ADDENDUM NO. 3

August 7, 2026

MERRILLVILLE HS CULINARY AND MEETING AREA RENOVATIONS AND MERRILLVILLE CSC CENTRAL OFFICE ADDITION AND RENOVATION PROJECT

This Addendum consists of pages ADD 3-1 through ADD 3-2 and attached Addendum No. 3 from Gibraltar Design dated August 6, 2026, and consisting of 5 pages, Specification Section 10 11 00 - Markerboards and Corkboards, Specification Section 28 13 00 - Access Control System, and 22 Drawings.

DRAWING
UNIT "T" MECHANICAL ROOF PLAN

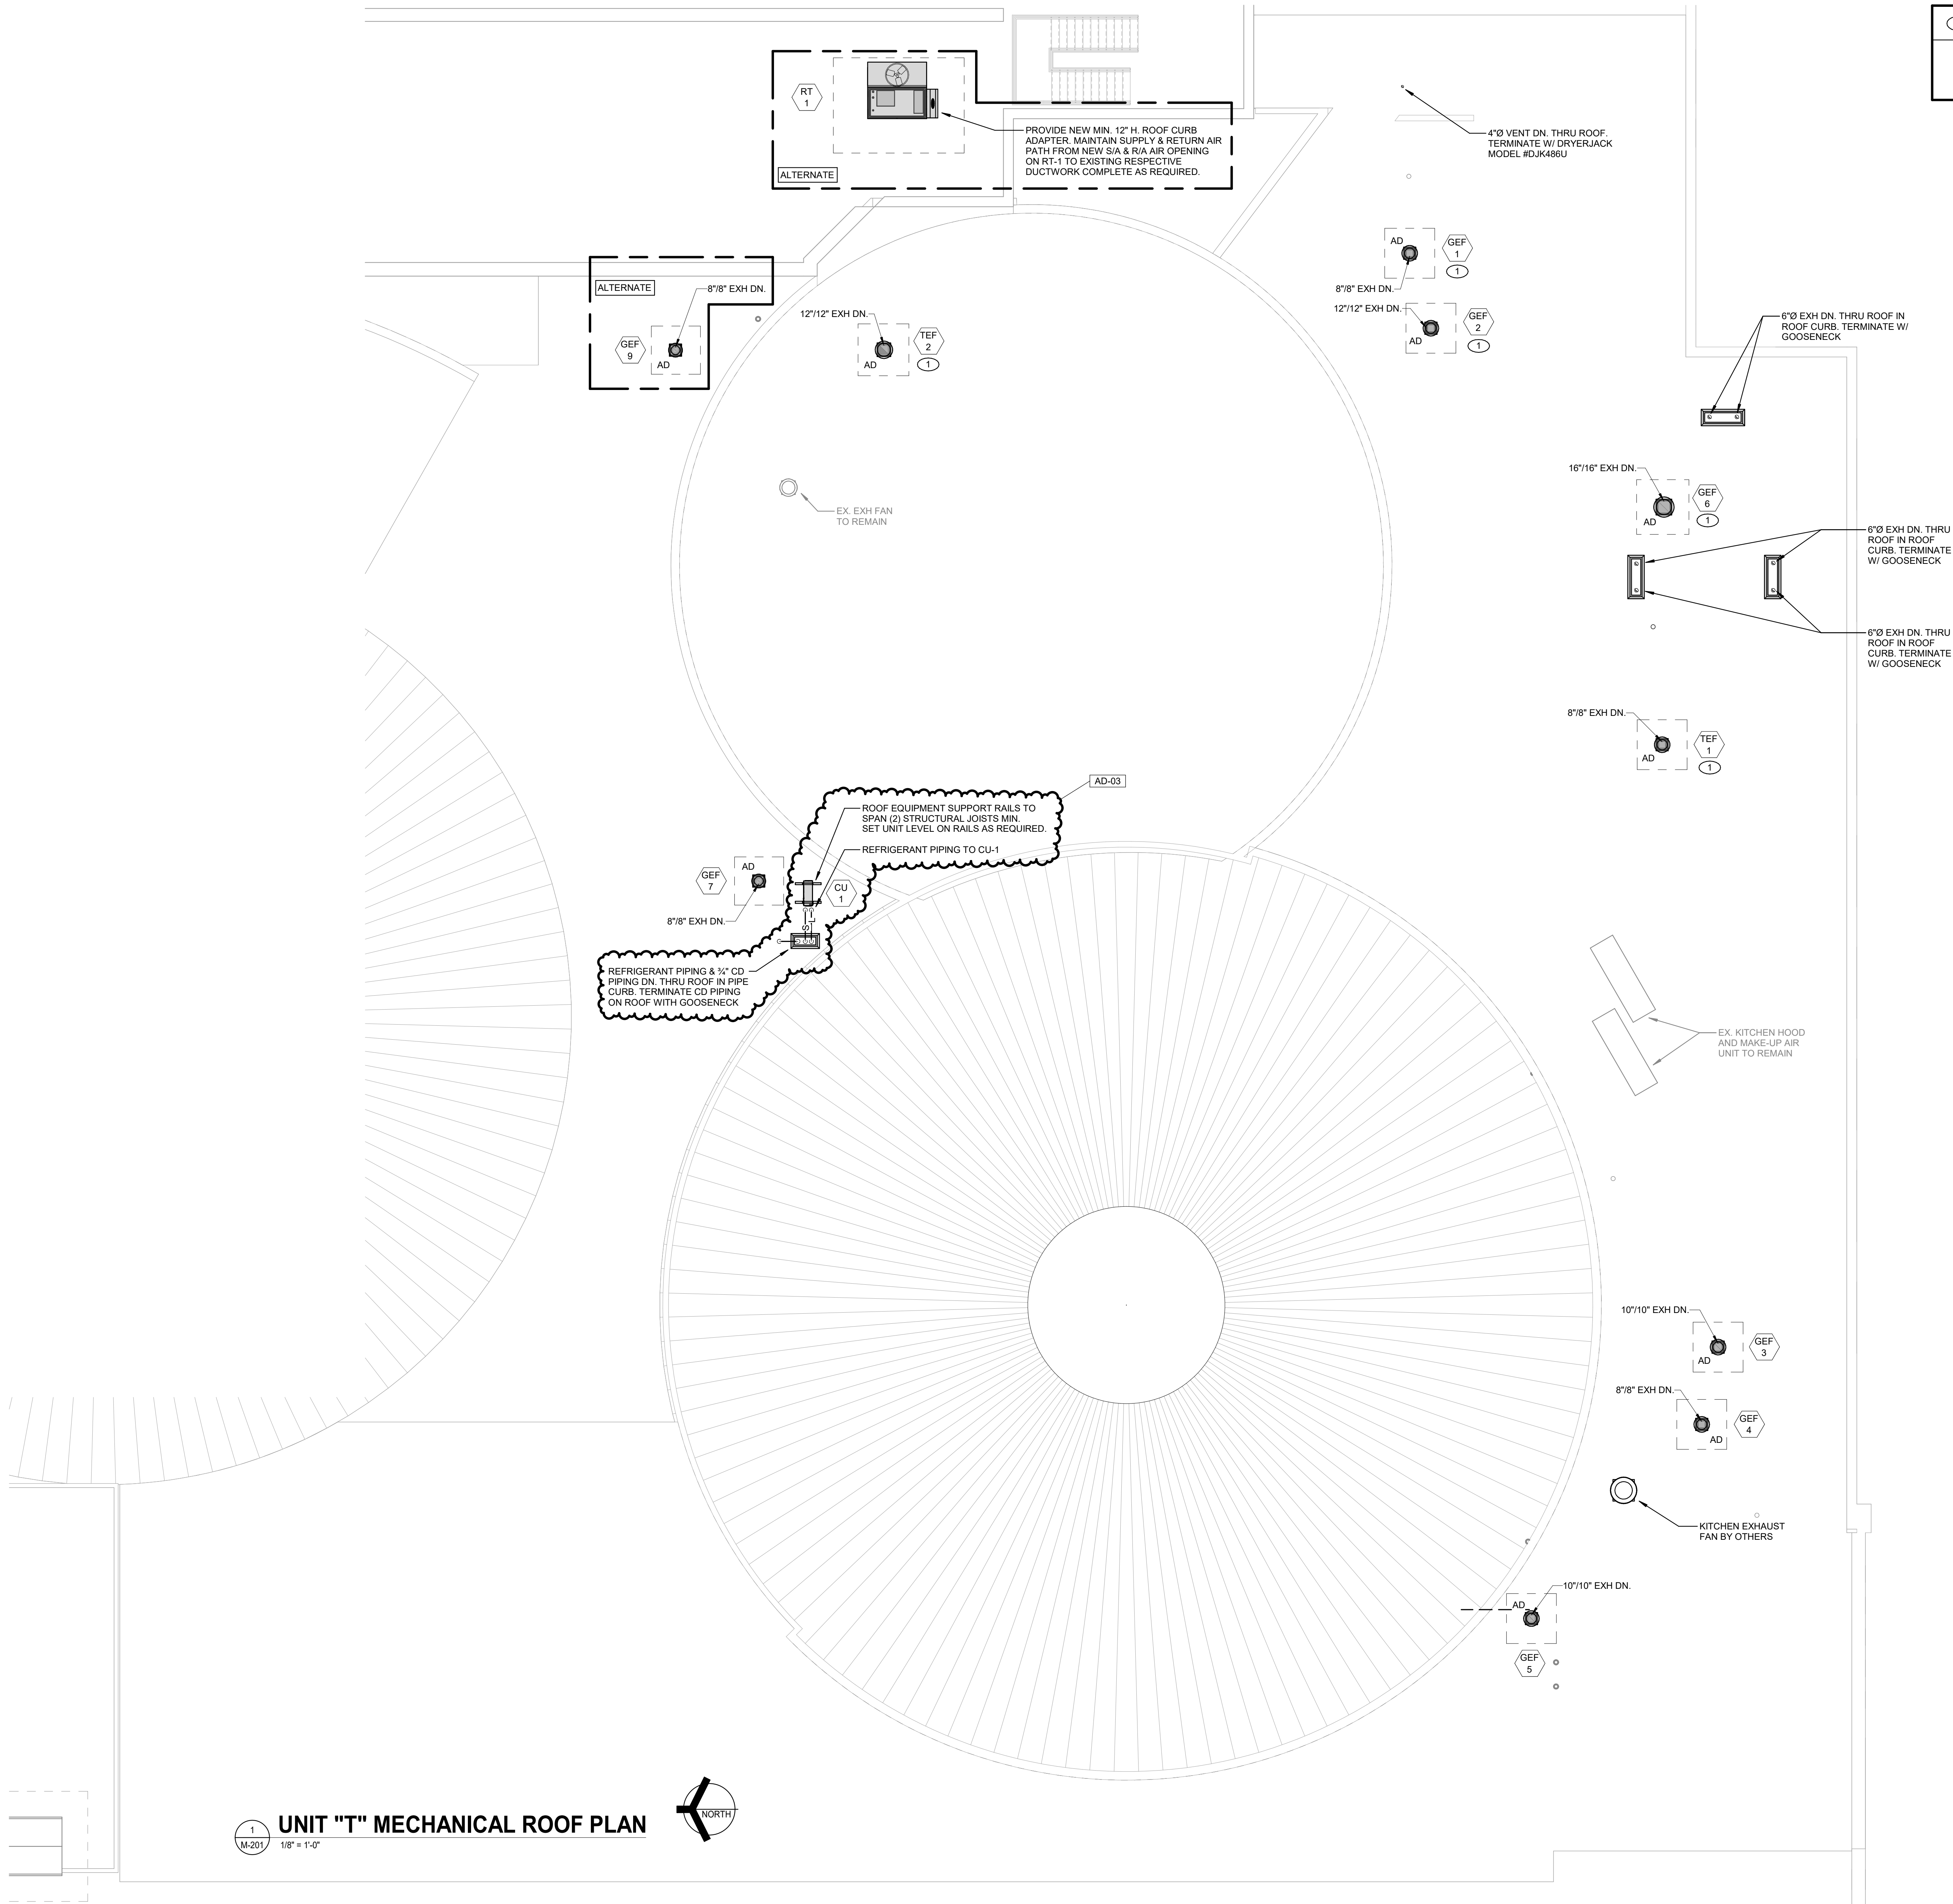
12. Sheet M-201

- A. Refer to revised, full-size drawing, included in this Addendum, for revisions.
 - 1. Added CU-1 to roof plan.

1 UNIT "T" ELECTRICAL LIGHTING FIRST FLOOR PLAN
EL121 1/8" = 1'-0"

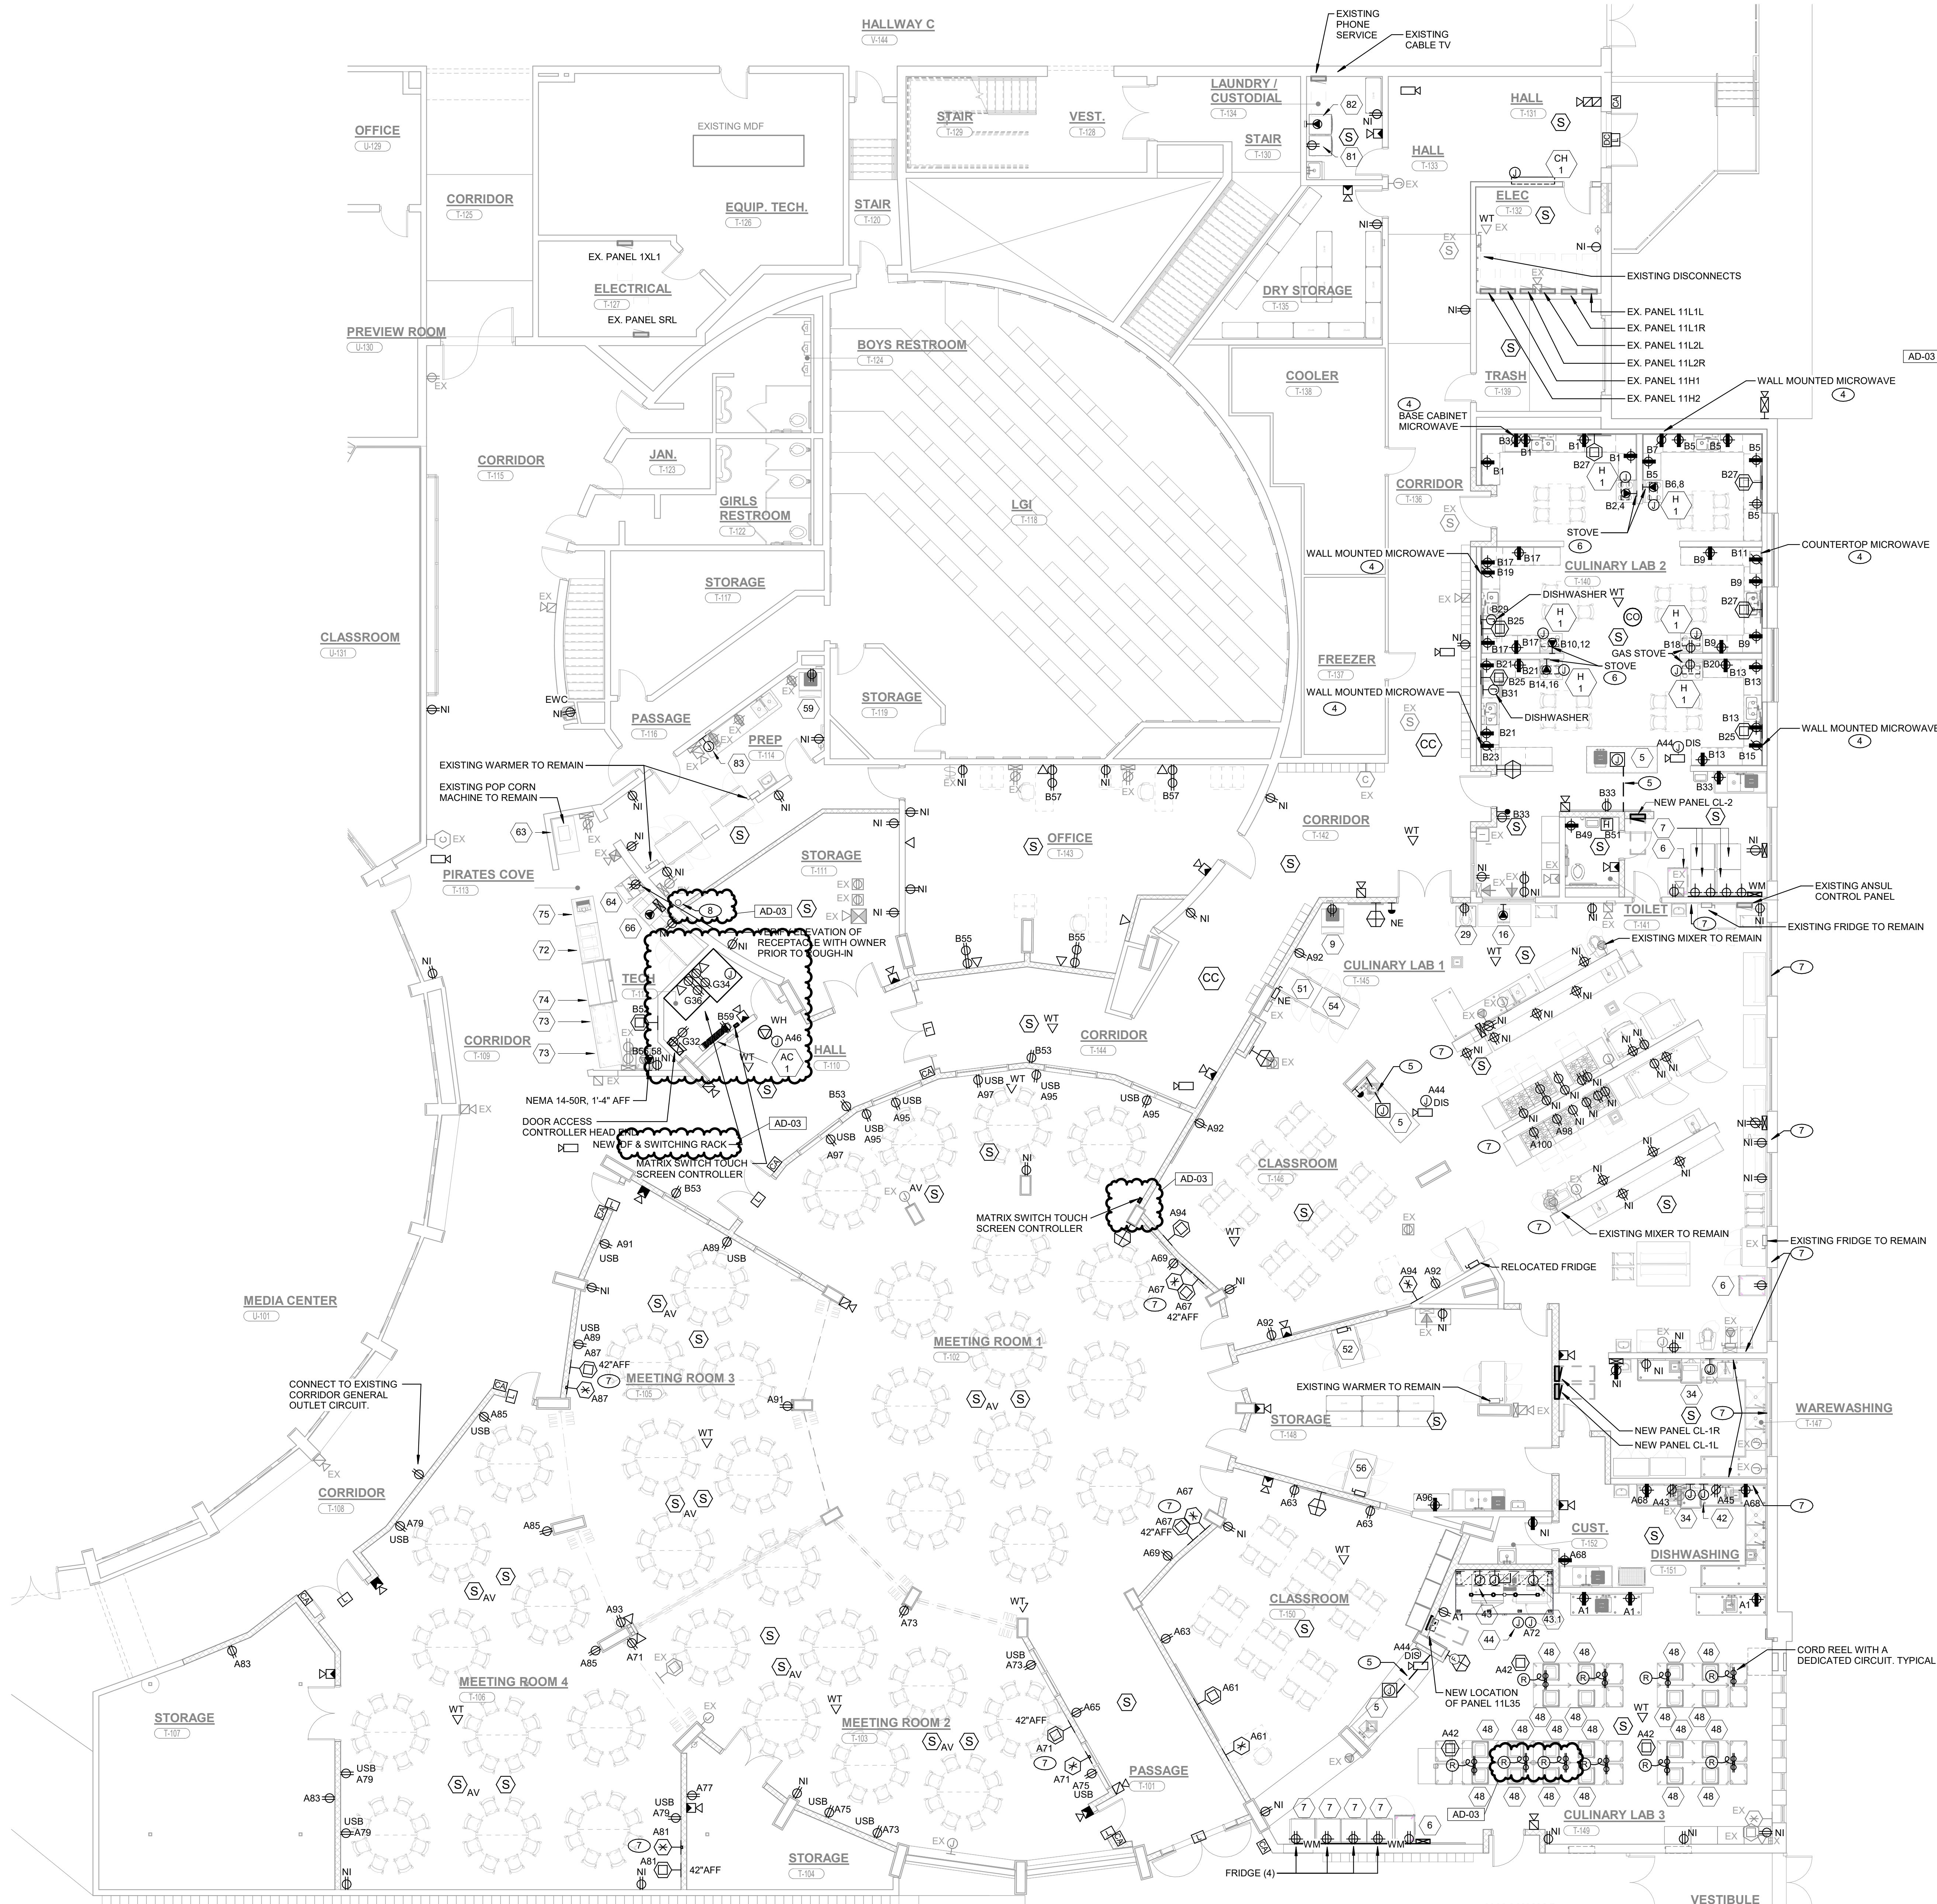
15. Sheet EL-121

- A. Refer to revised, full-size drawing, included in this Addendum, for revisions.
 - 1. Revised multiple sheet notes
 - 2. Removed divider sensors
 - 3. Added local switching to meeting room 1
 - 4. Relocated several switches

1 UNIT "T" ELECTRICAL POWER FIRST FLOOR PLAN
1/8" = 1'-0"

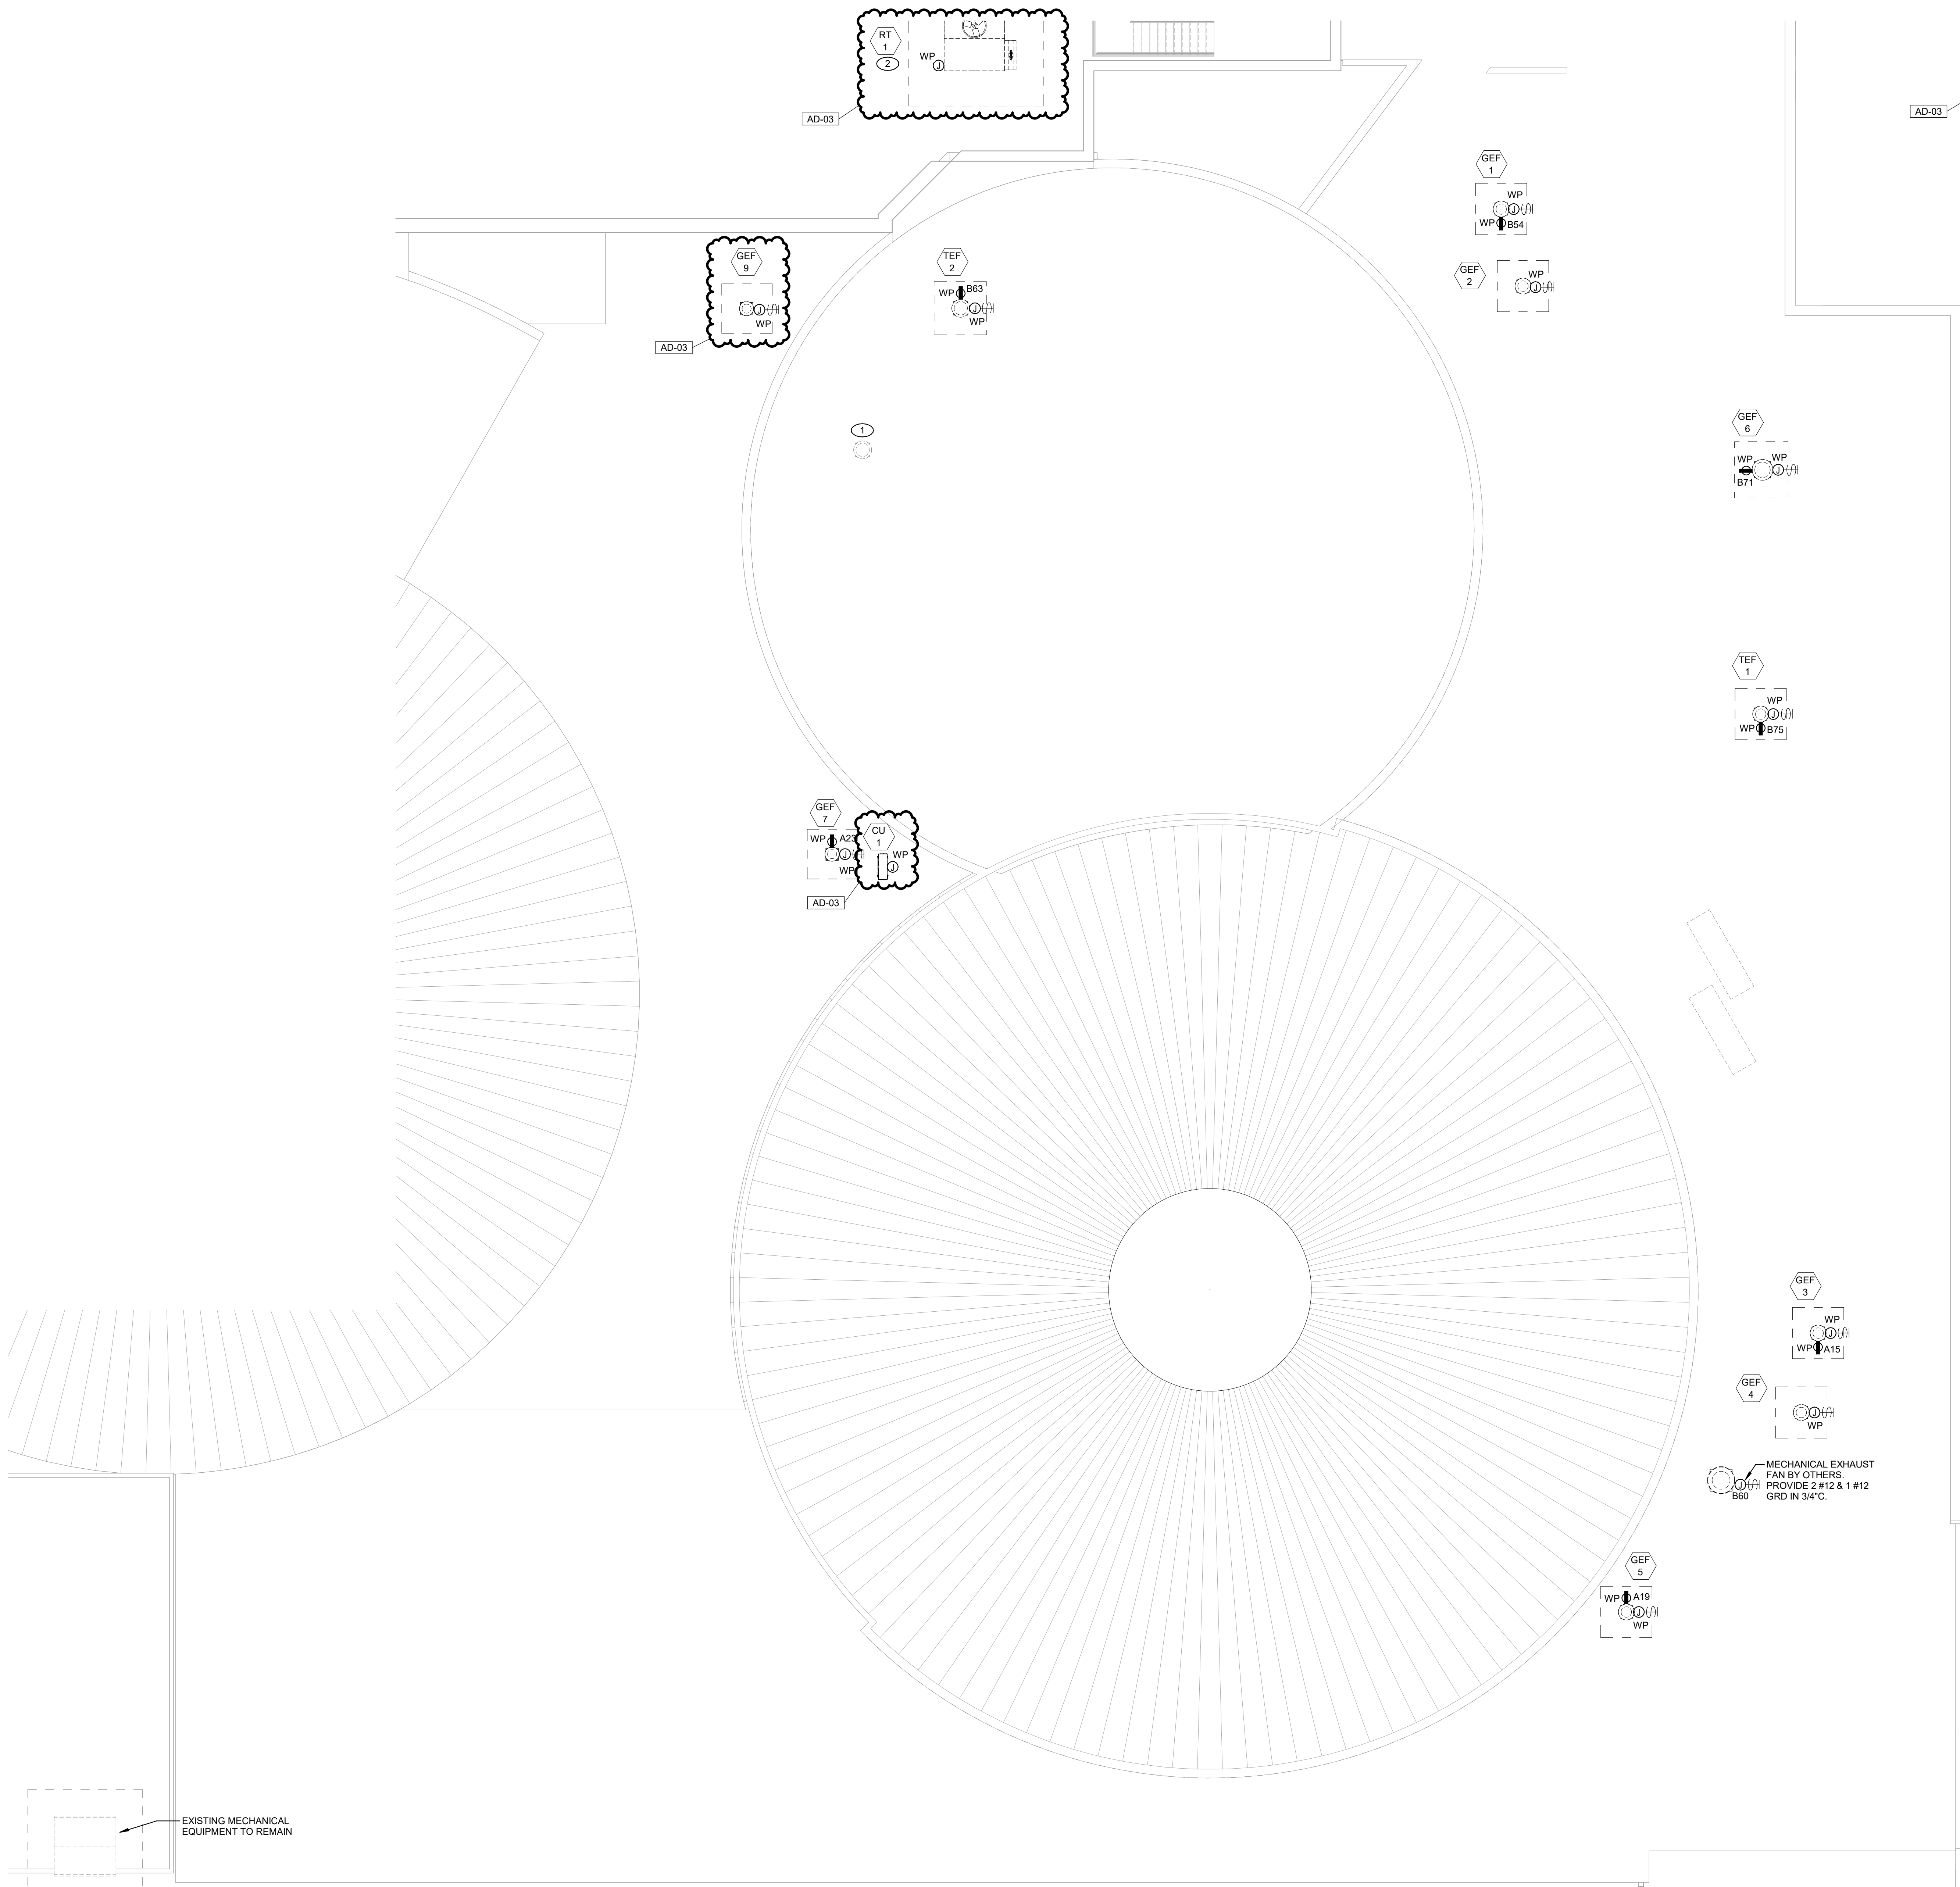
16. Sheet EP-121

- A. Refer to revised, full-size drawing, included in this Addendum, for revisions.
 - 1. Added General Note #4.
 - 2. Added a reel cord.
 - 3. Revised reel cord layout.
 - 4. Added mechanical equipment AC-1.
 - 5. Added Sheet Note #8.
 - 6. Added conduit drop for sheet note 8.
 - 7. Updated Tech Room layout.
 - 8. Relocated touch screen controller.
